RE: Design and Construction Standards Variance Request
Ride and Drive Automotive Research Lot (SP12-29)

**SUBJECT: Ride and Drive Automotive Research Lot (6.6318 Acres), SP#12-28,
Traffic Review of Preliminary Site Plan**

Revised Preliminary Site Plan Ride & Drive Automotive Research

Re: Ride and Drive Automotive Research Lot (SP#12-29)
Wetland Review of the Preliminary Site Plan

CLIENT PROJECT No. 1104 EX
DATE ISSUED 06/08/12
SHEET No. C-1

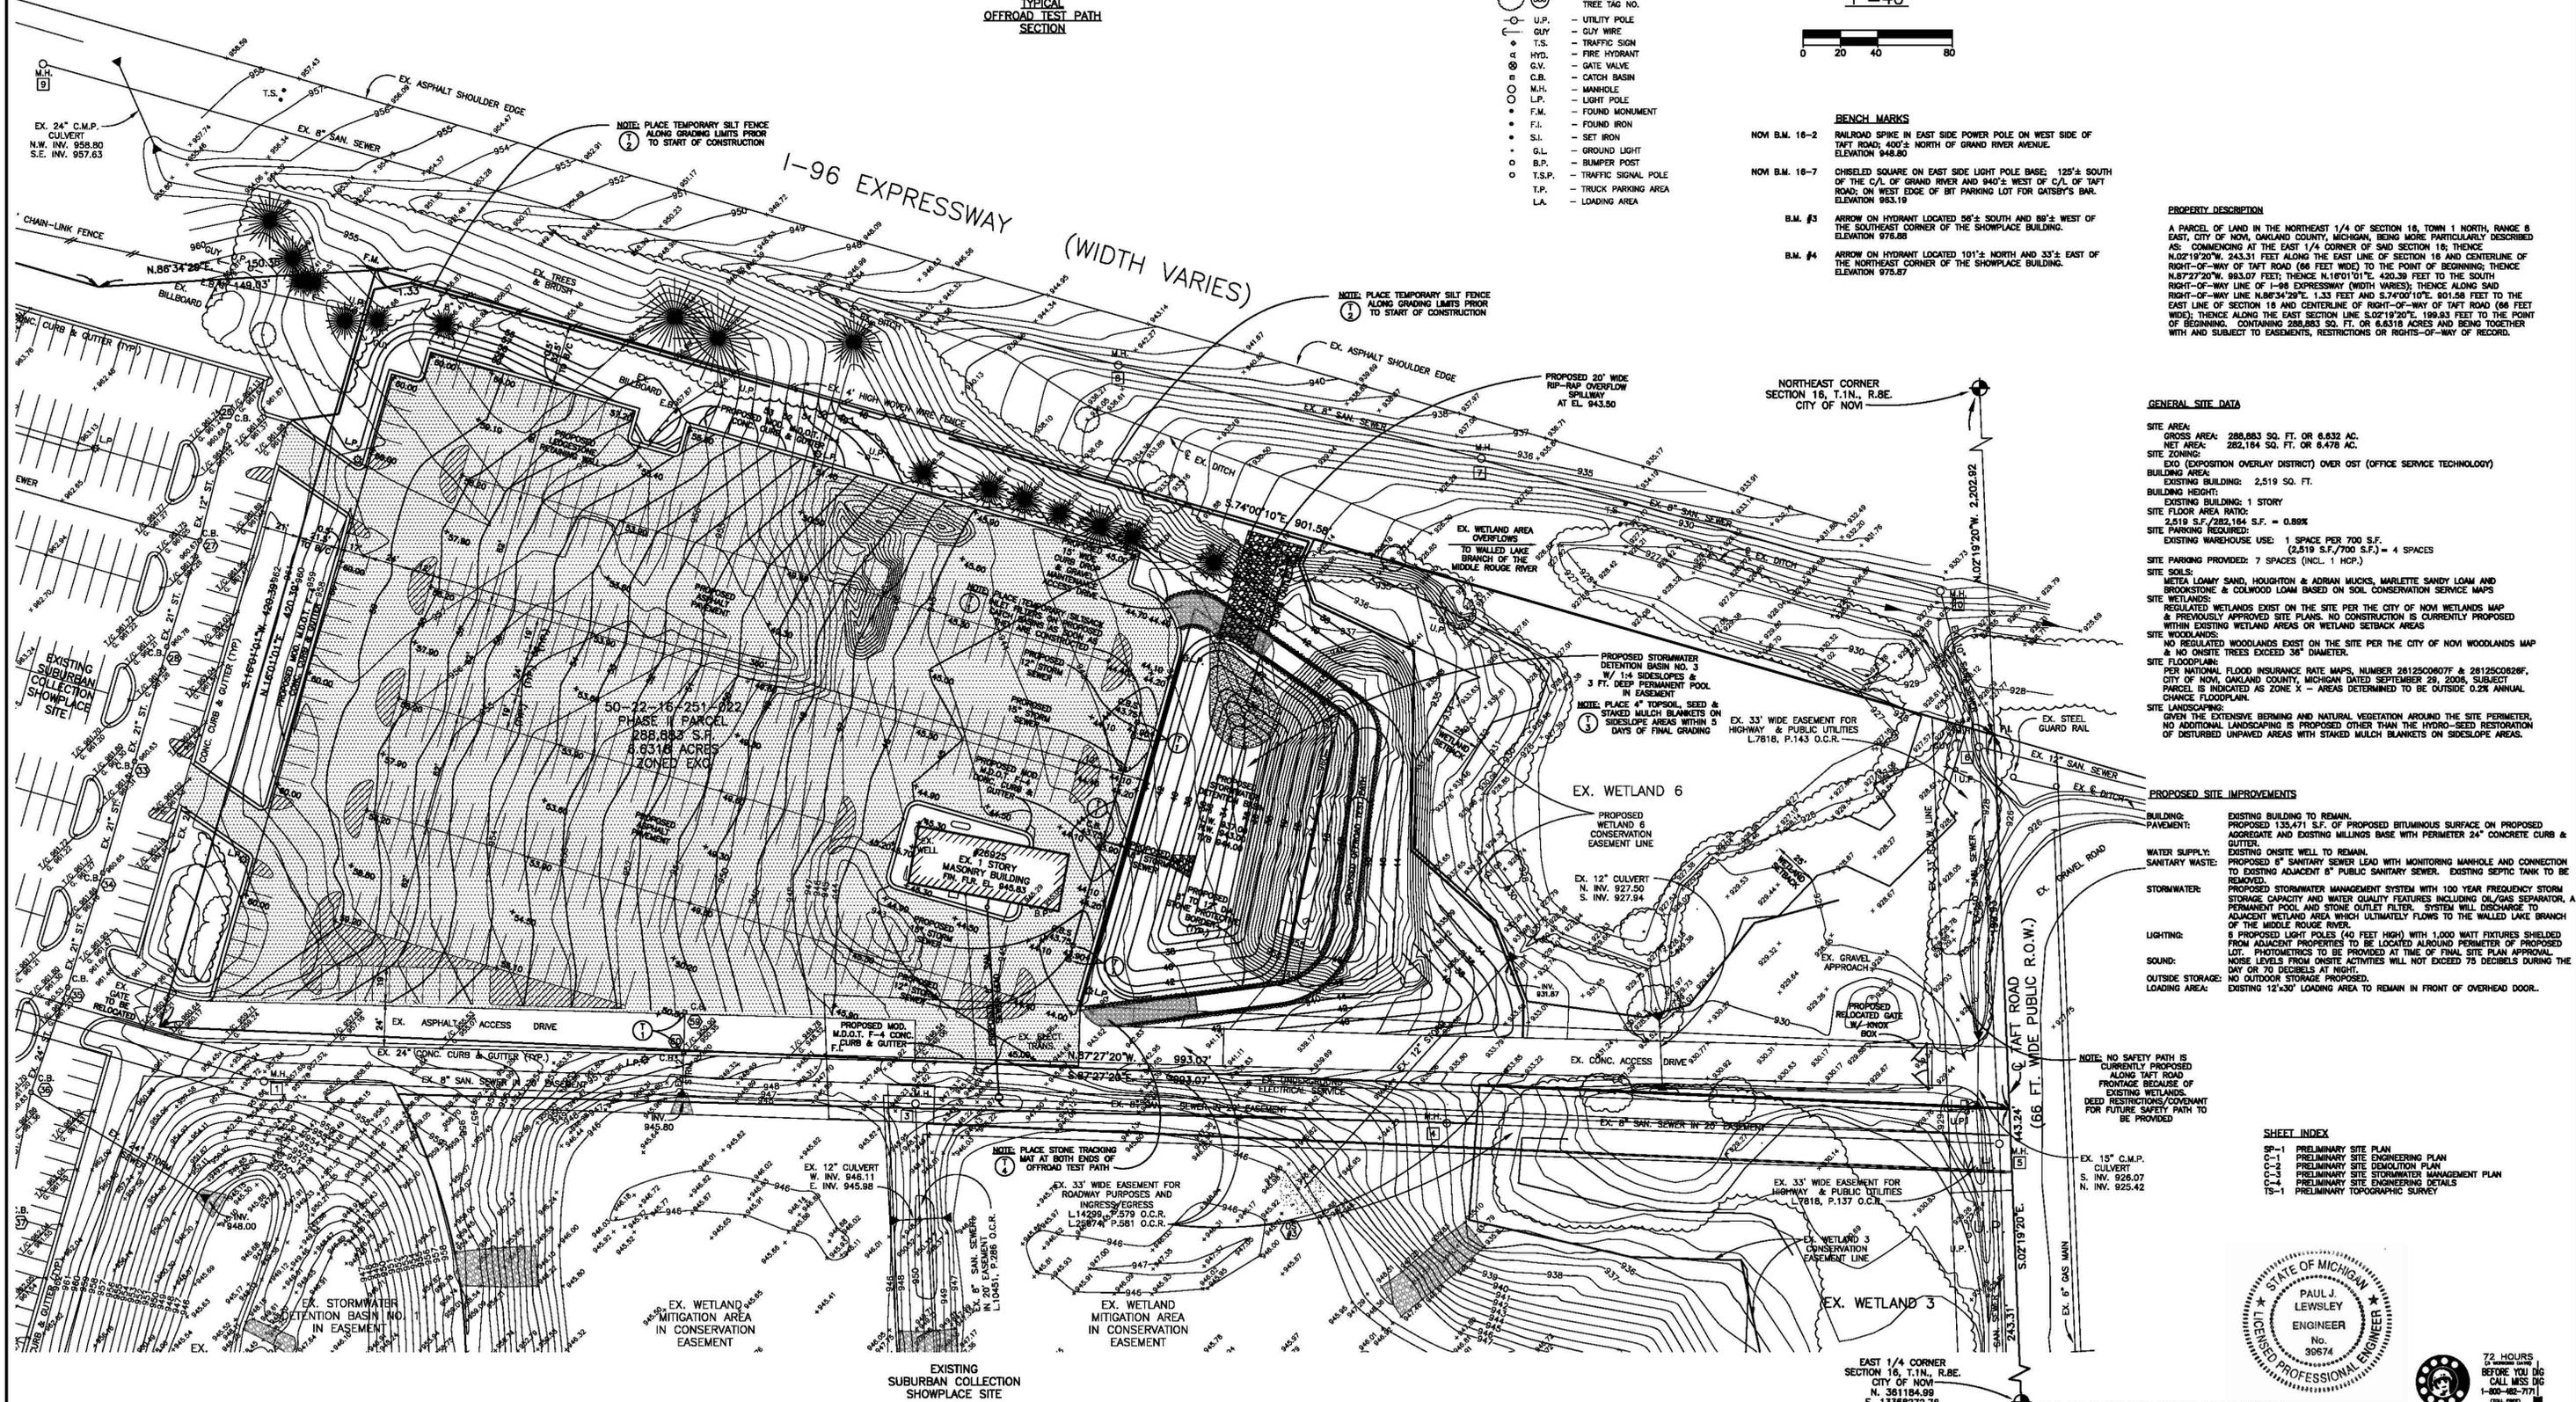
9. The applicant proposes to stripe the overflow parking spaces in "muted tones"; most likely, in dark green paint. For the record, this is contrary to the long-established City policy (stated in the *Site Plan and Development Manual*) that pavement markings comply with the *Michigan Manual on Uniform Traffic Control Devices*, which requires that white be used to mark regular parking spaces. **At a minimum, the final site plan must clearly label the color of all new pavement markings. Also, the seven permanent parking spaces noted above need to be reconciled with the "muted" spaces shown on sheet C-1 for the same area.**

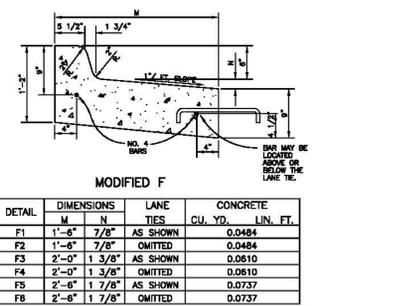
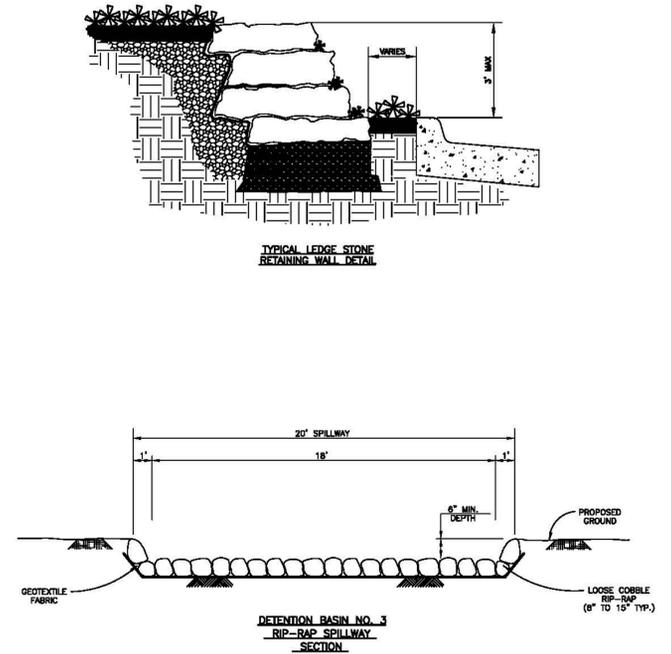
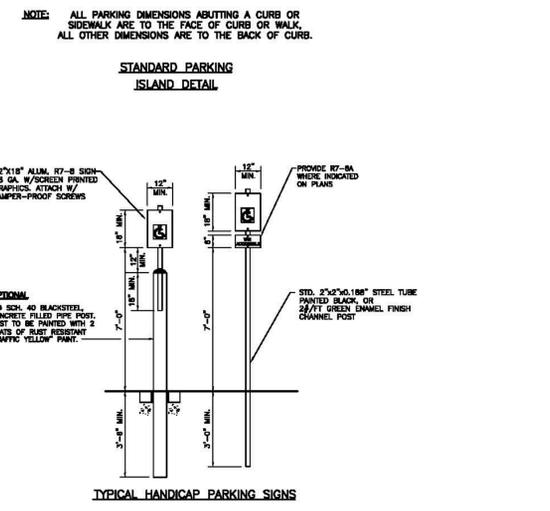
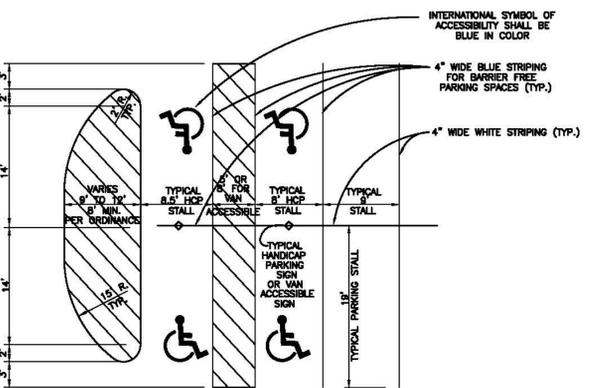
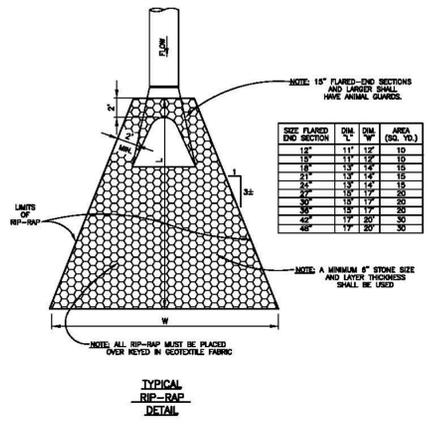
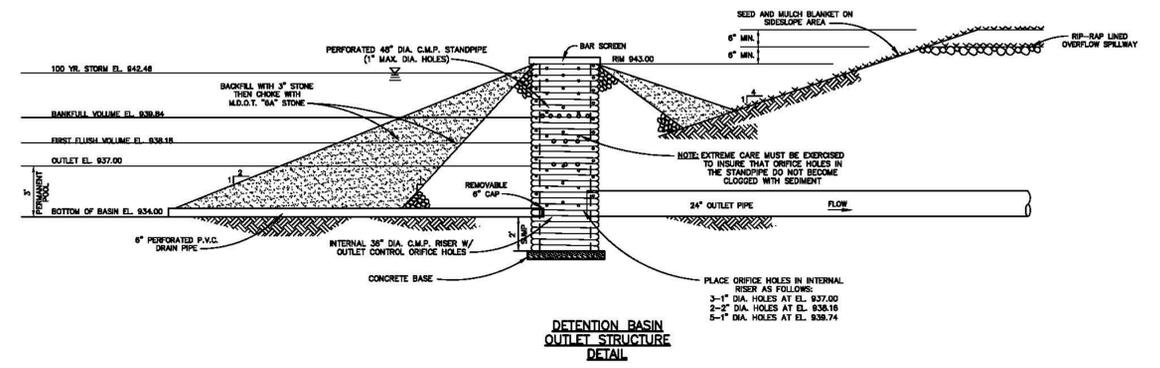
12. The standard detail on sheet C-4 for handicap parking signs should be updated to reflect the sign code now used for the **VAN ACCESSIBLE** plate in the 2011 **MMUTCD (R7-8P rather than R7-8A).**
